Statesville Office (704) 878-5305 Mooresville Office (704) 660-3625 PERMIT # 238898

SEPTIC IMPROVEMENT PERMIT / AUTHORIZATION TO CONSTRUCT / OPERATION PERMIT / EXISTING SYSTEM

SUBDIVISION: Northlake SECTION: 2 LOT # 27 LOT AREA: .7ac DESIGN FLOW: 360gpd L.T.A.R.: .3

Attached is a proposed design for a PPBPS Septic System with PRESSURE MANIFOLD distribution for a 3 bedroom single family residence on Northlake Lot 27, 160 Wylie Trl, Statesville, Iredell County, North Carolina.

AS BUILT SKETCH

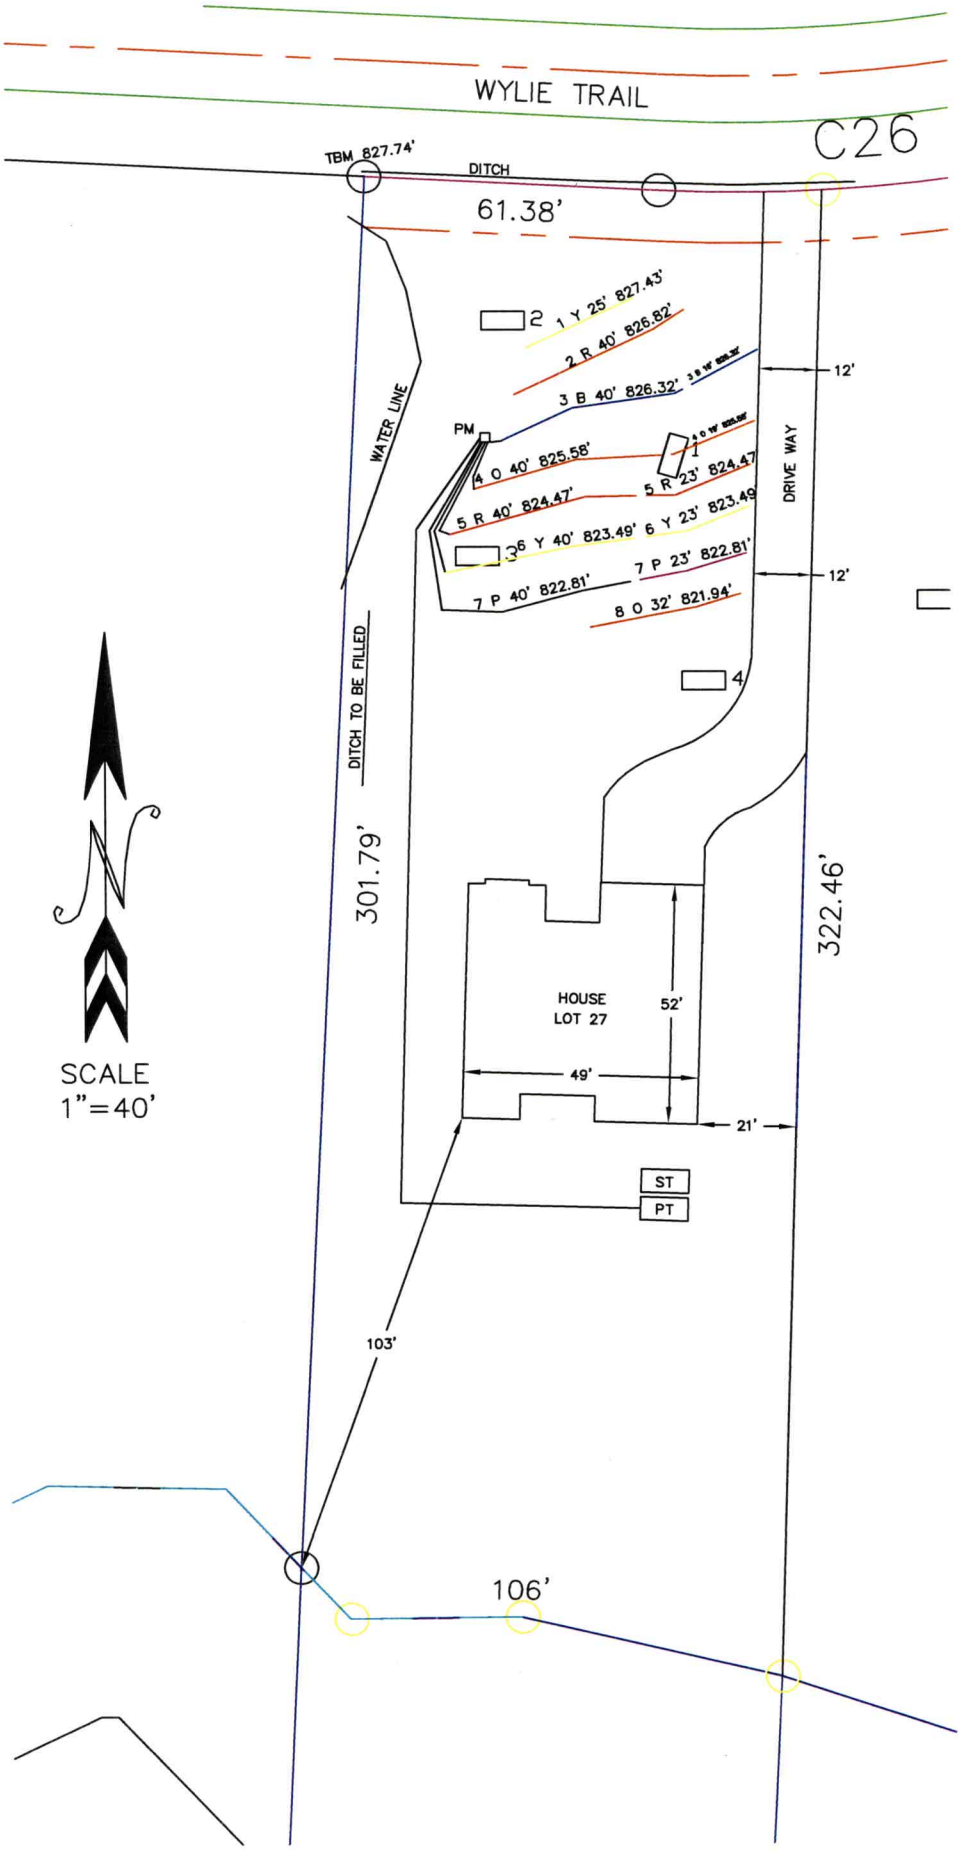
Comments / Conditions: * Construction drive must be moved to follow permit. * Drive cannot exceed 12' from property line. Do not issue AC until a site visit has been made to confirm the drive is relocated to 12' from property line.

Site Visit 2/17/20 - Culvert by road relocated for drive, gravel was removed + new drive was marked.

Date	Initials
Drain Lines Checked	2-21-20	CCN
Tanks Checked	2/17/20	KW
Pressure Manifold or Valve Box Checked	2-21-20	CCN
Pressure Head Set	2-21-20	CCN
Electrical Checked	3/3/2020	PSB
Floats Set	2-26-20	CCN
Alarm Checked	2-21-20	CCN
Maintenance Contract Y (N) N/A	—	—
Comments: - tanks need risers 2/17/20 KW ✓ - Supply line checked 2.18.20

- top 2 drain lines checked 2/19/20 KW
